**Environmental Assessment**  
**MKI Southern Grand Banks Seismic Program, 2014–2018**  
**Addendum**

**14 July 2014**  
**Project No. SA1250**

# **Environmental Assessment of MKI Southern Grand Banks Seismic Program, 2014–2018 Addendum**

**Figure 1. Transportation Routes Relevant to White Rose.**

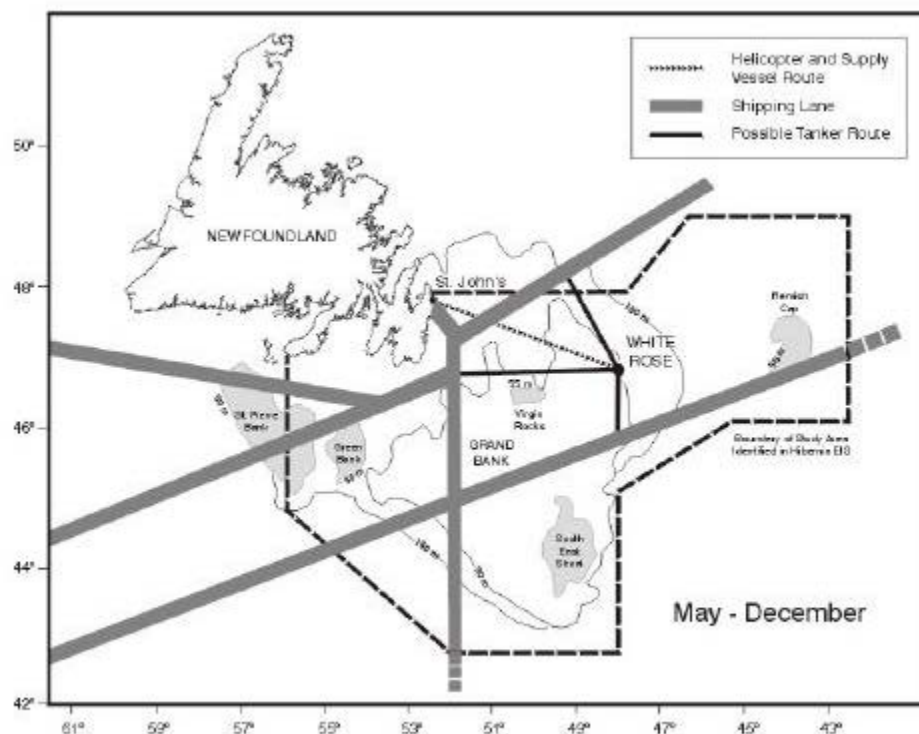
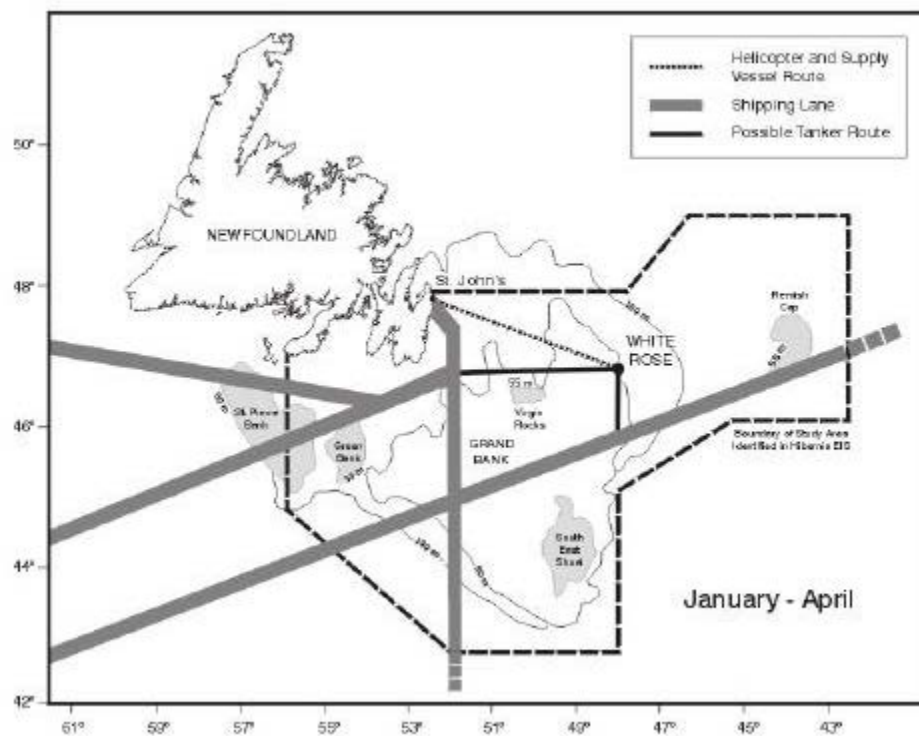
**Figure 5.4 Page 218** - it would be appear to have been pertinent to include the shipping lanes for Terra Nova and White Rose petroleum production also.

**MKI Response:** Figure 5.4, p.218, was obtained from the Sydney Basin Offshore Area SEA (JW 2007). The Proponent was unable to obtain track data for shipping lanes for the Terra Nova and White Rose petroleum production facilities, however it is assumed that vessels follow the most direct route possible (given sea and ice conditions) between the production sites and St. John's Harbour. The following figures were produced by Husky (Oil) for the *White Rose Oilfield: Comprehensive Study Report* (see Figure 2.2 in Husky 2001) and by Petro-Canada for the *Development Application: Terra Nova Development Environmental Impact Statement* (see Figure 5.5-1 in Petro-Canada 1996) to represent helicopter and supply vessel routes for the White Rose platform and Terra Nova FPSO, respectively:
